FOR PERCOLATION TESTING AND SITE EVALUATION

RE: **Perc Test Report, PROPOSED LOT 10, PROIA PROPERTY, [a re-subdivision of Clifton C. Link Property, Lot 1], receipt number A536791**

RE: Proia Property – Percolation Testing Fees

RE: Clifton C Link Property Lot 1 (resubdivision); Perc Cert comment

SITE INSPECTION SHEET

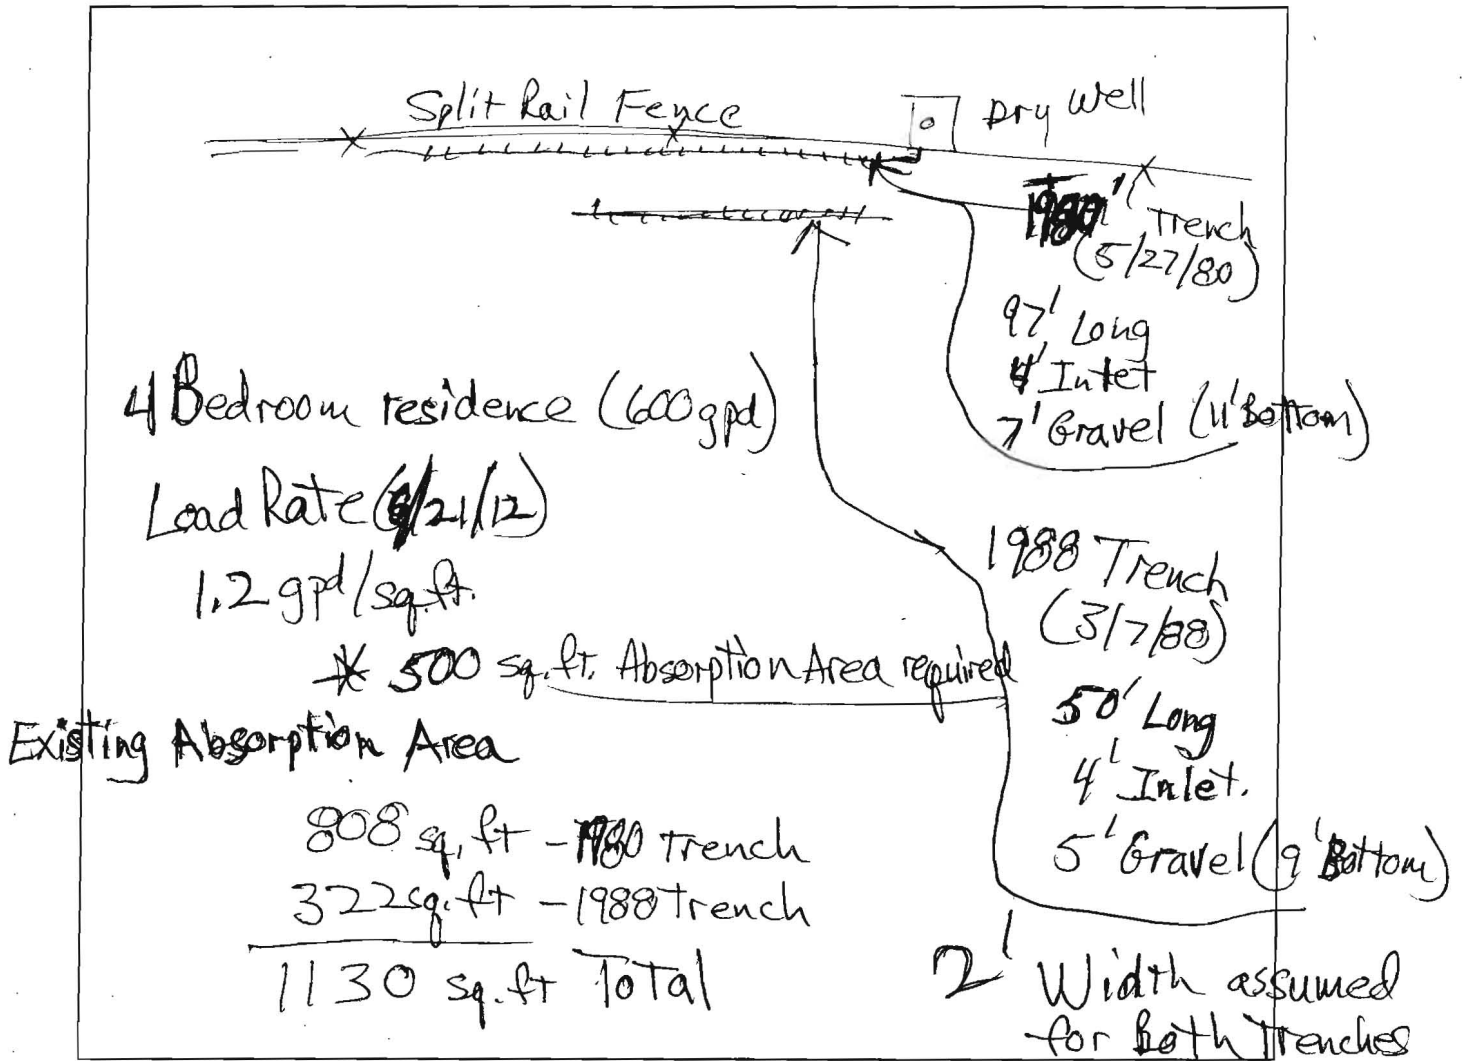
COMMENTS: 1130 ft² Absorption Area (total) in 2 Trenches
Abandon dry well; connect two trenches to
Distribution box.

SITE INSPECTION SHEET

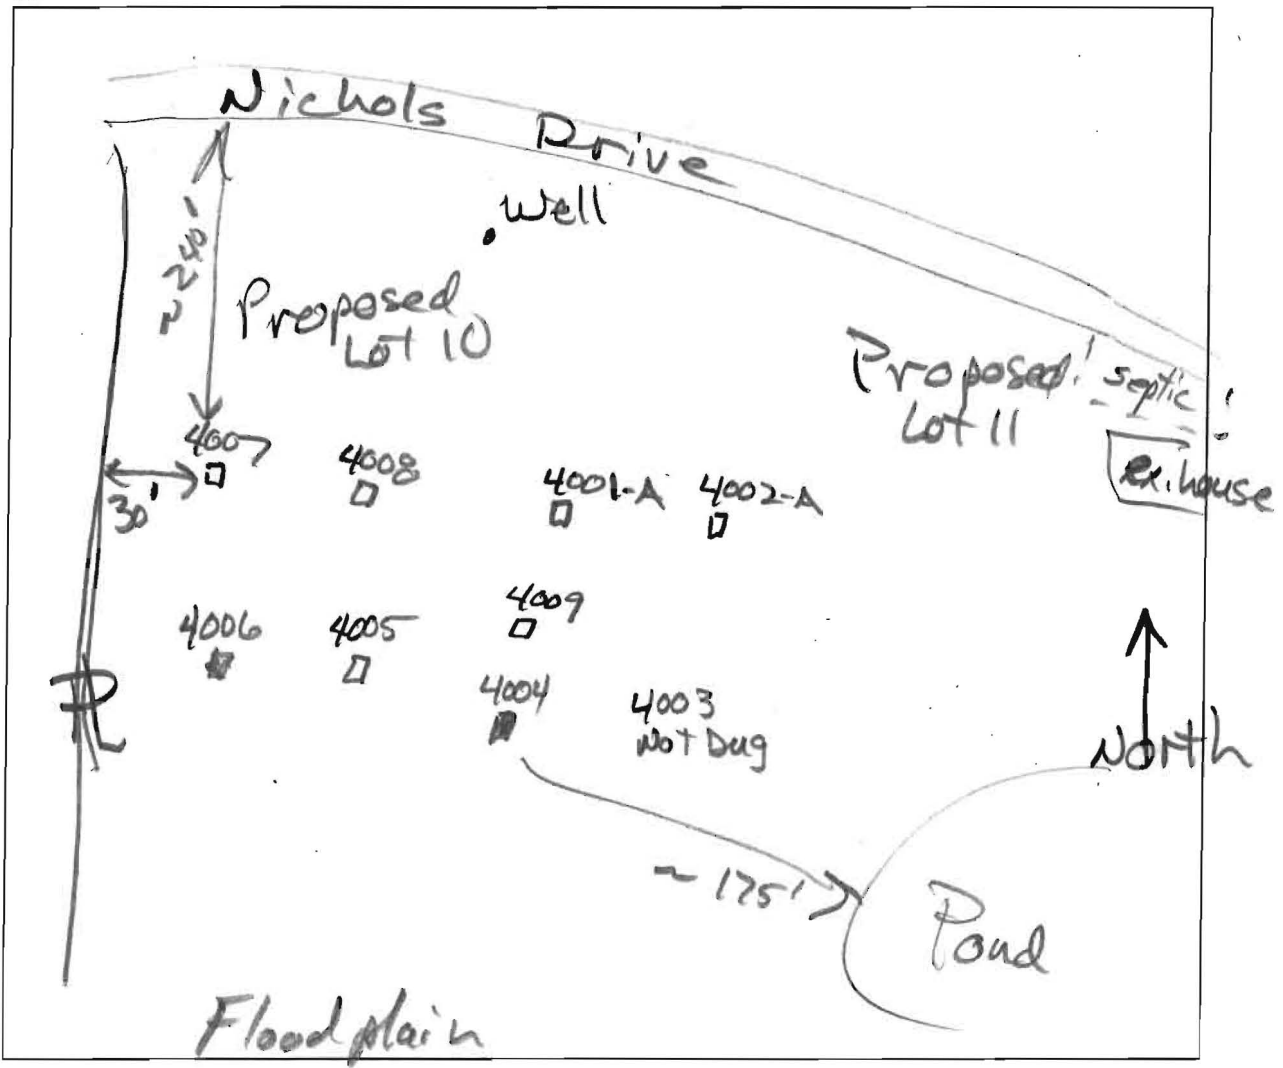
COMMENTS: 2 Tests Fail, #4004 for water table within 24" of surface

6 Tests Pass

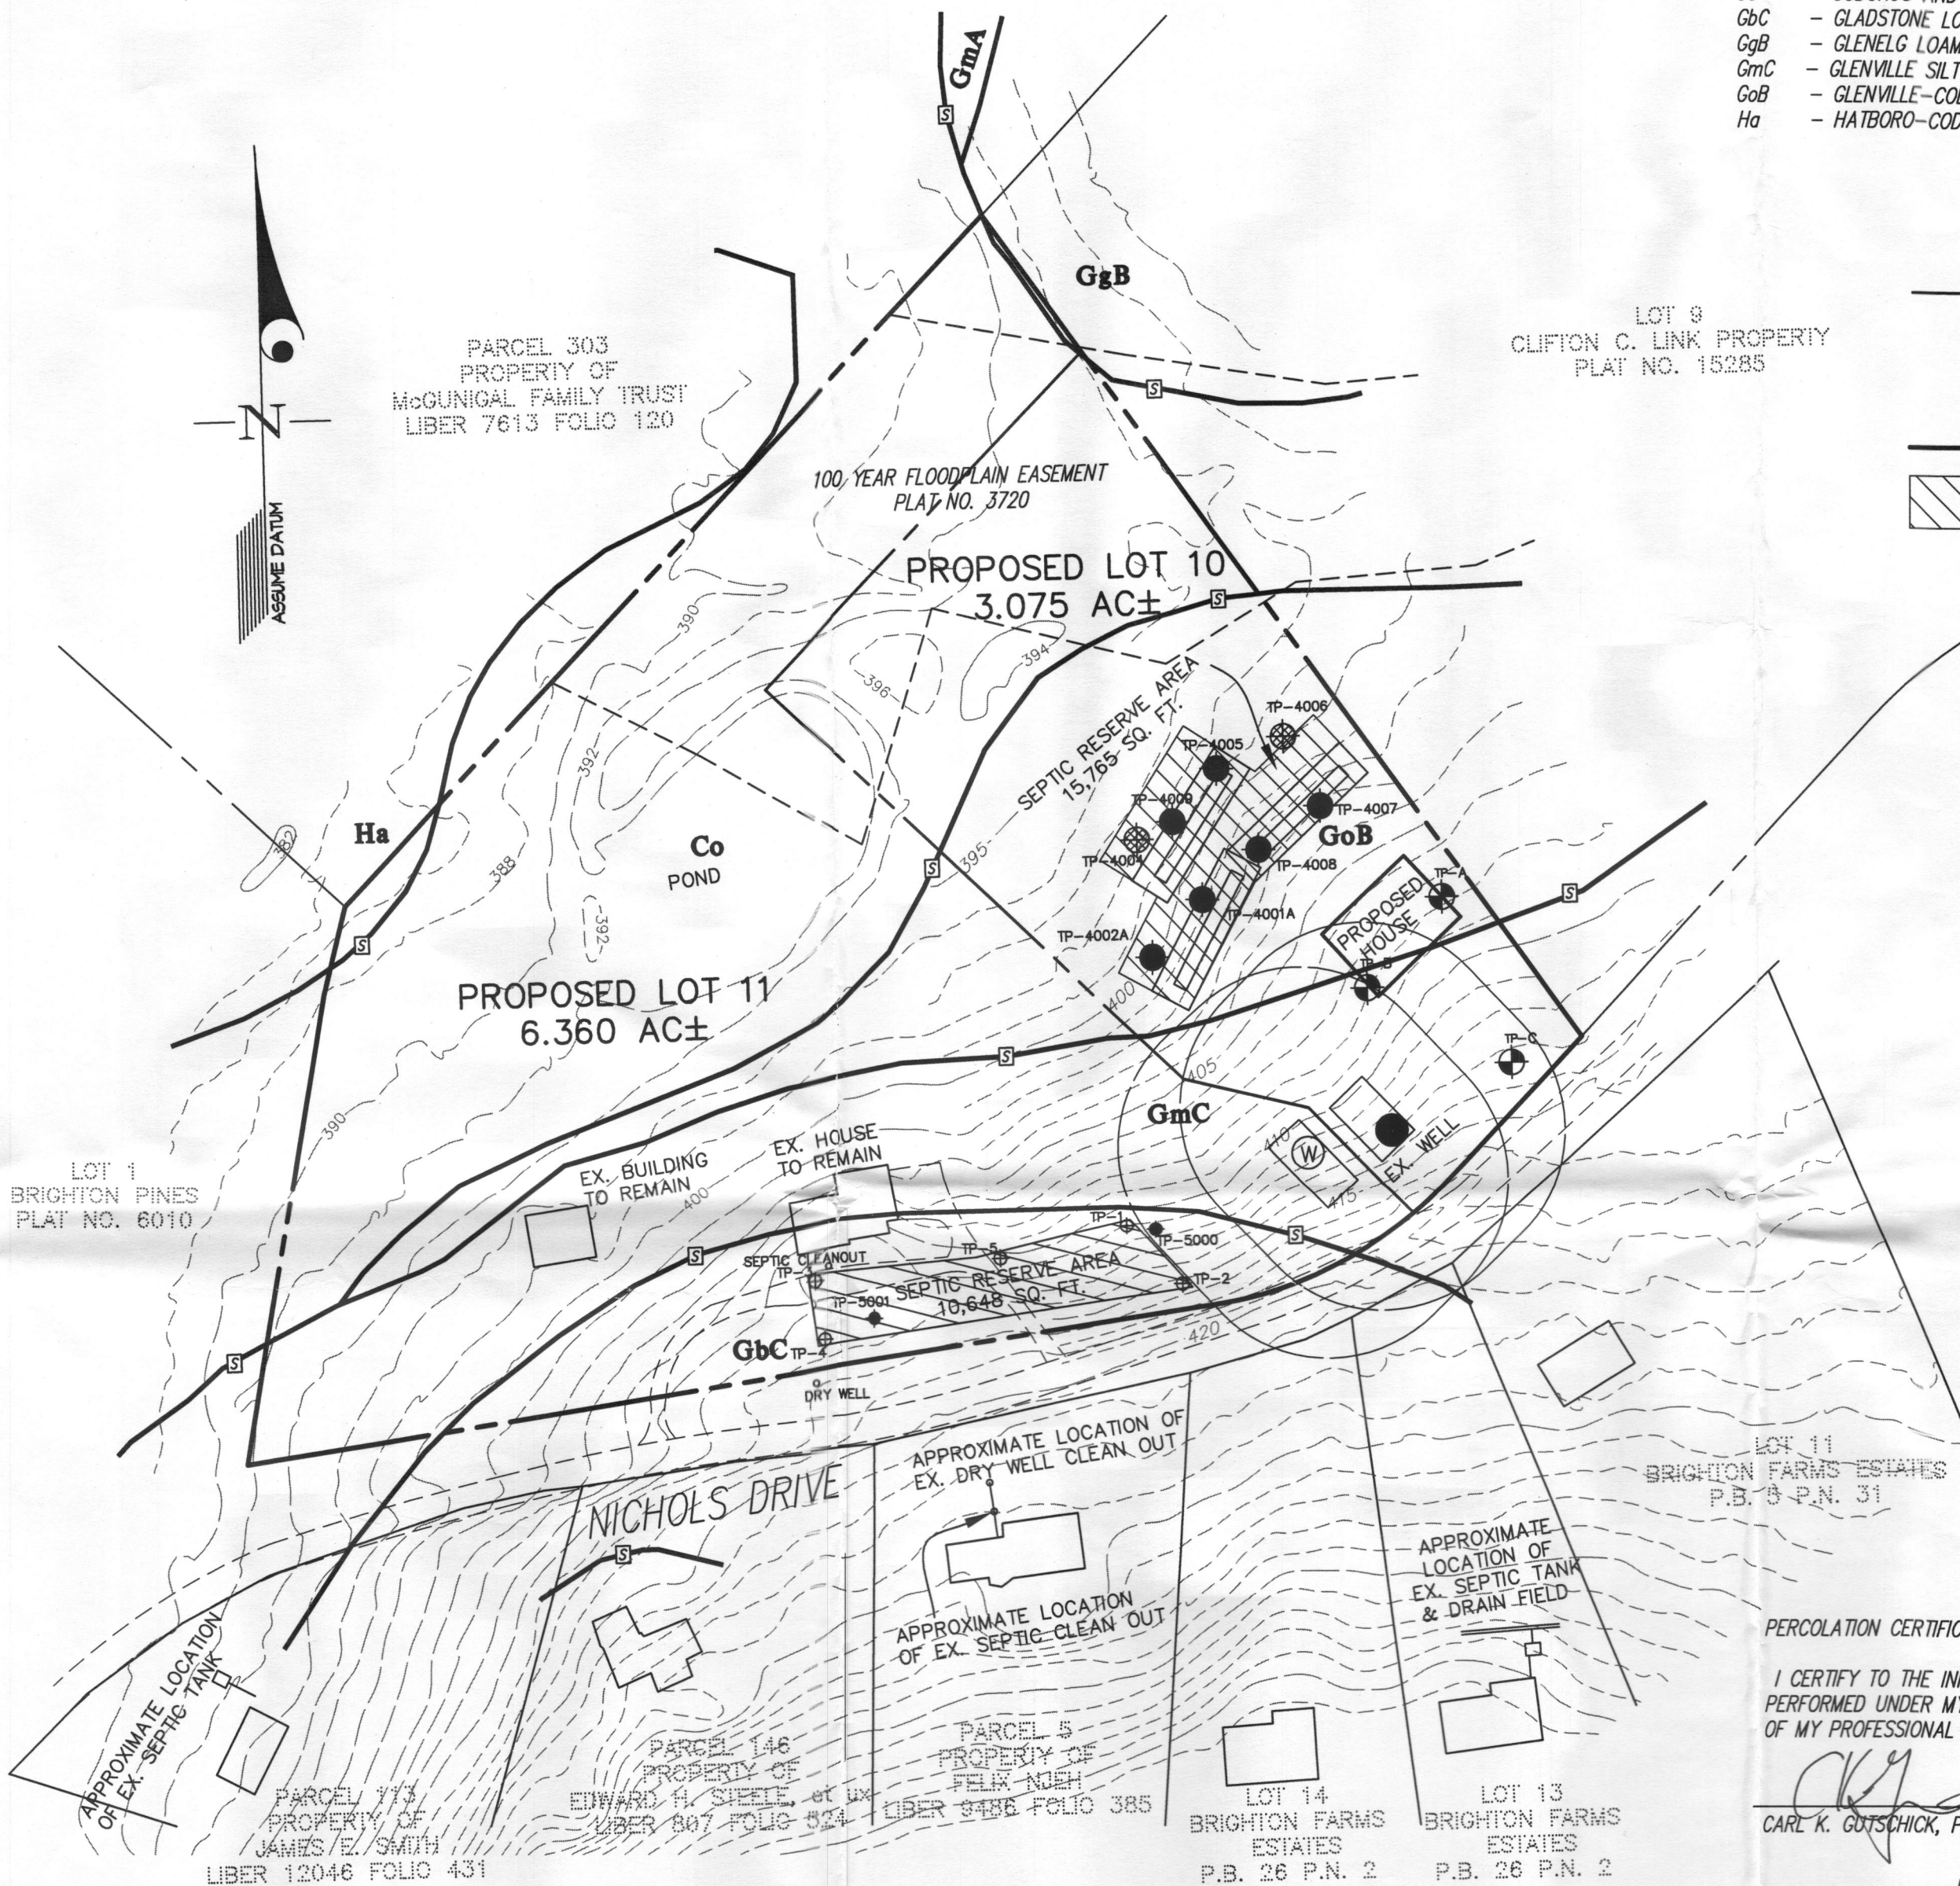
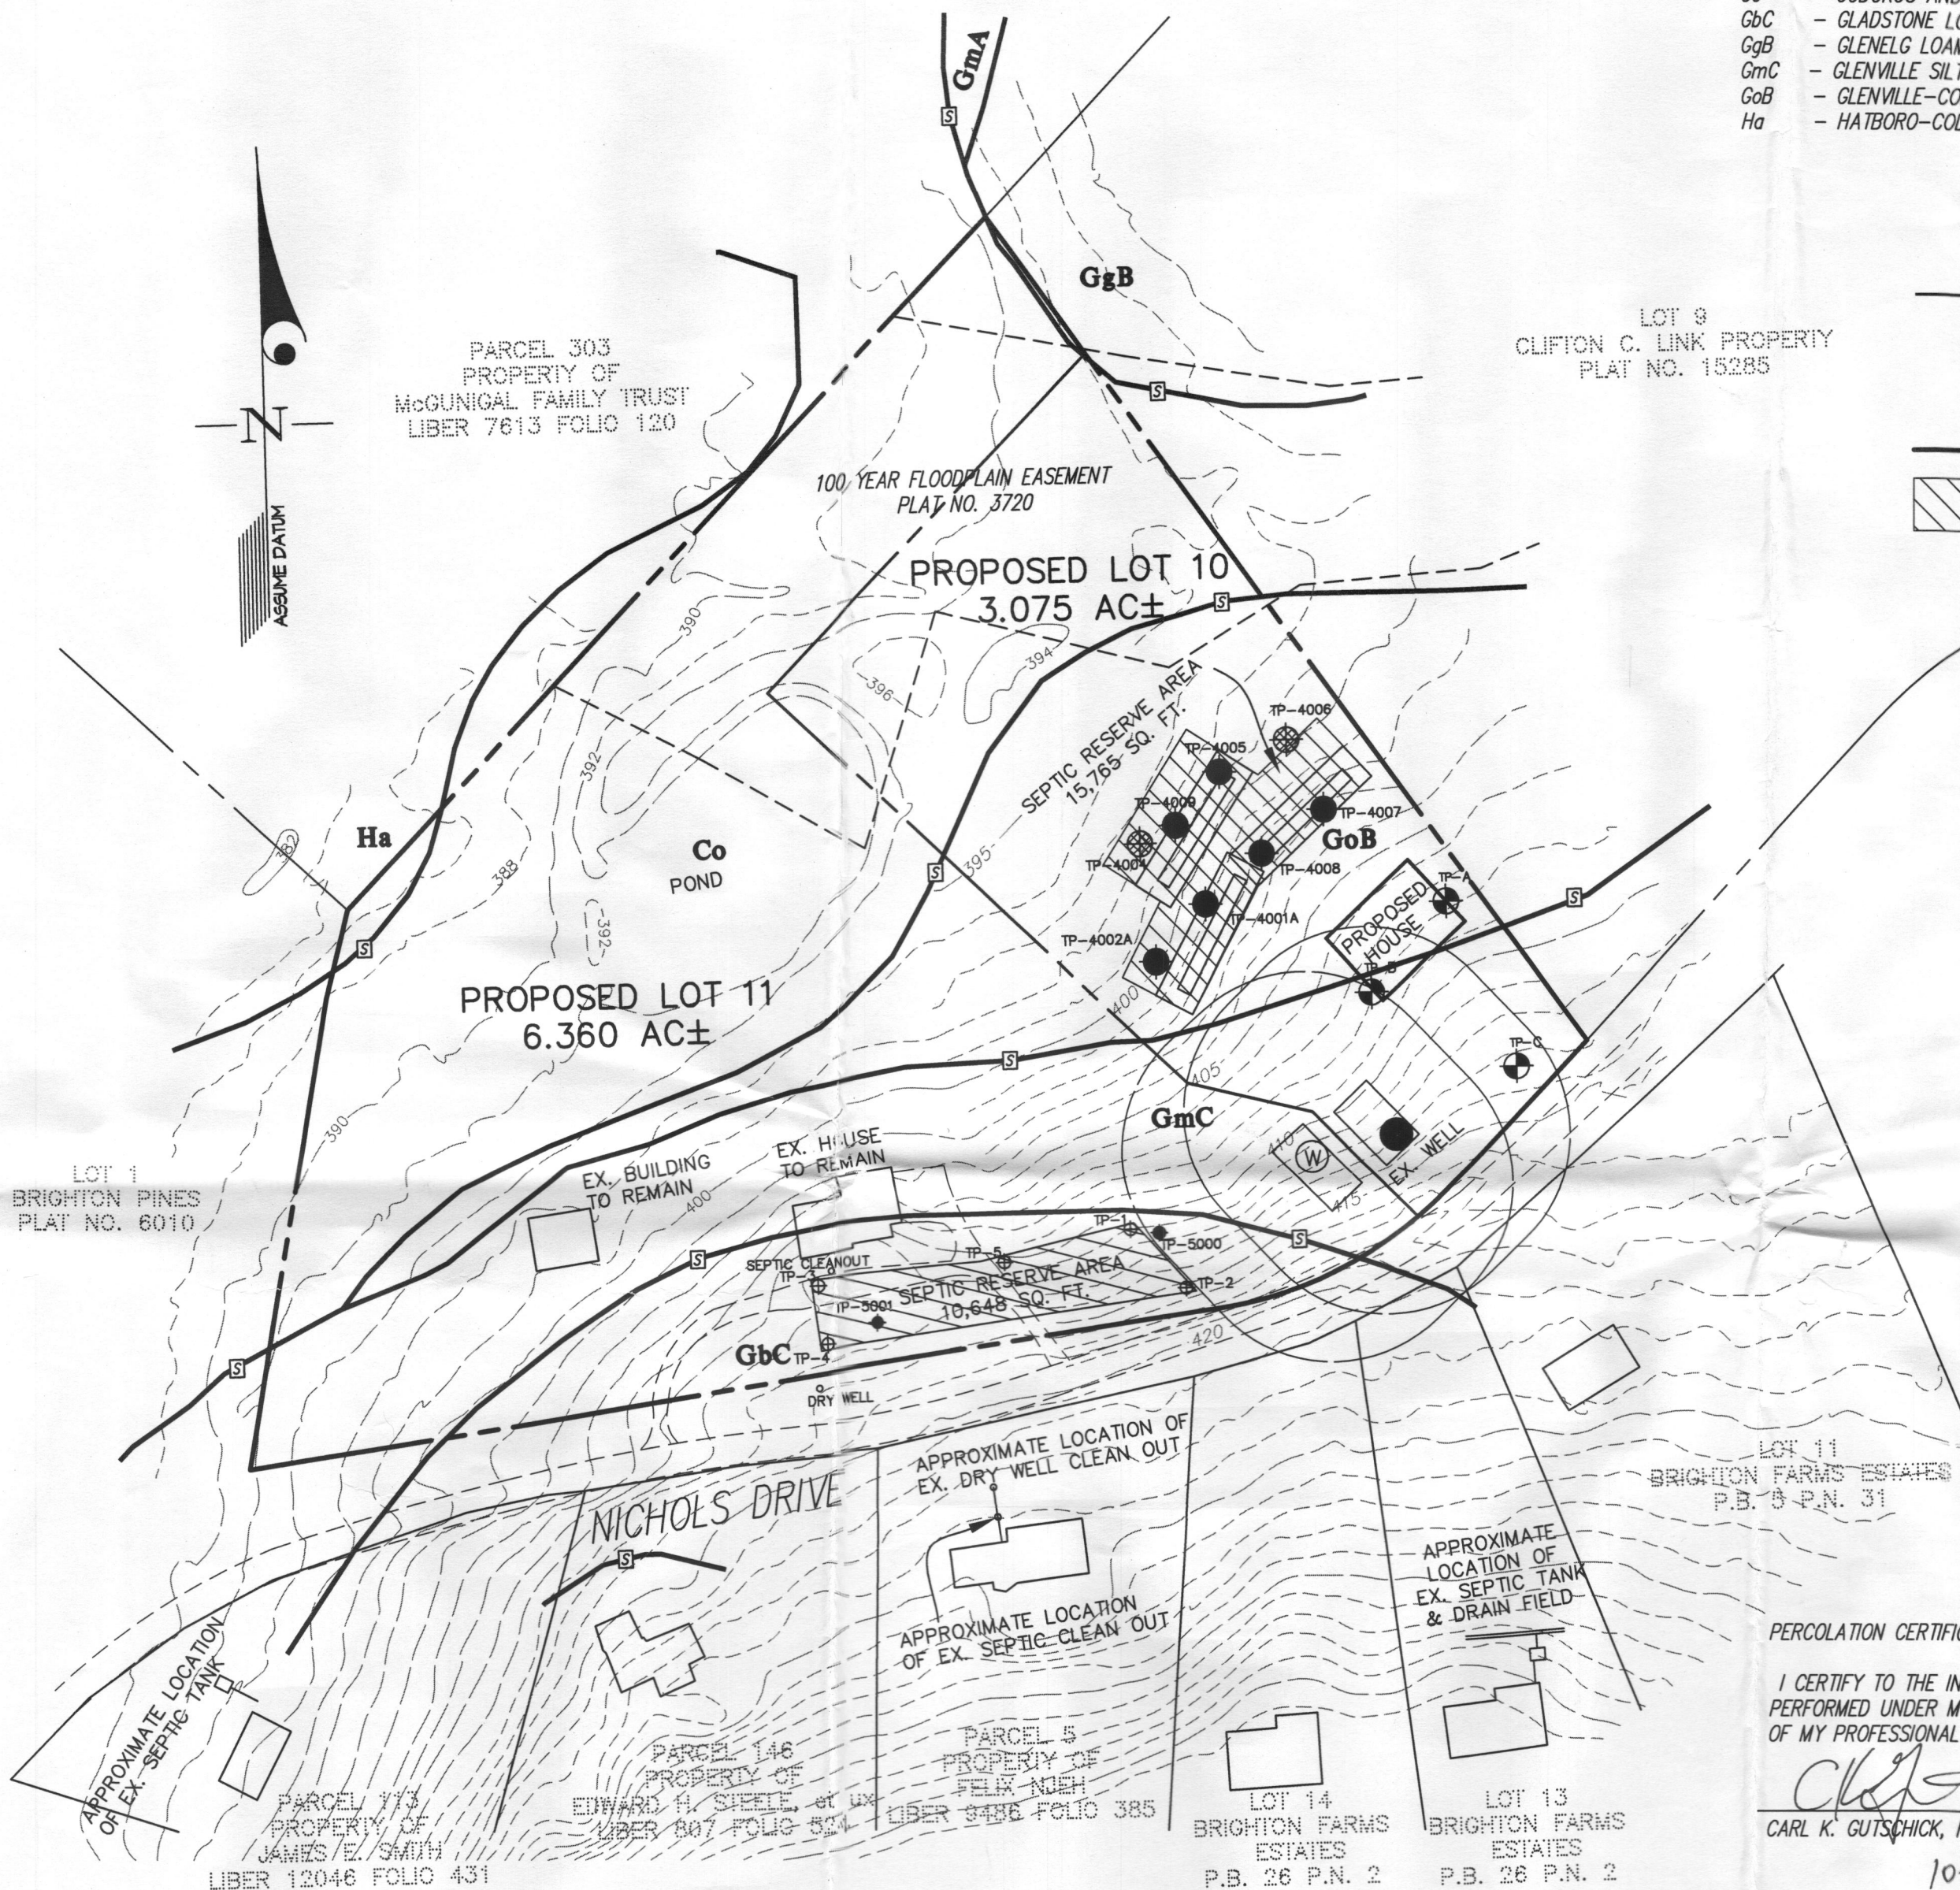
The following edits are needed on the submitted Percolation Certification Plan.

1. Label the areas (i.e. **the total square footage**) in each of the polygons represented as septic reserve areas on Lots 10 and 11. Please notice that the three sand mounds with downslope infiltration area (on Lot 10 of this proposal) comprise only one septic reserve area.

2. Replace Note 14 with the following:

PRIOR TO SUBMITTAL OF FINAL PLAT MYLAR, THE EXISTING DRY WELL SERVING THE RESIDENCE AT 13630 NICHOLS DRIVE WILL BE PROPERLY ABANDONED. A DISTRIBUTION BOX IS TO BE INSTALLED, CONNECTING TO THE TWO EXISTING TRENCHES. THE HEALTH DEPARTMENT MAY APPROVE THE SUBDIVISION WHEN THE ATTENDING ENVIRONMENTAL SANITARIAN APPROVES THE INSTALLATION OF THE DISTRIBUTION BOX AND THE ABANDONMENT OF THE DRY WELL.
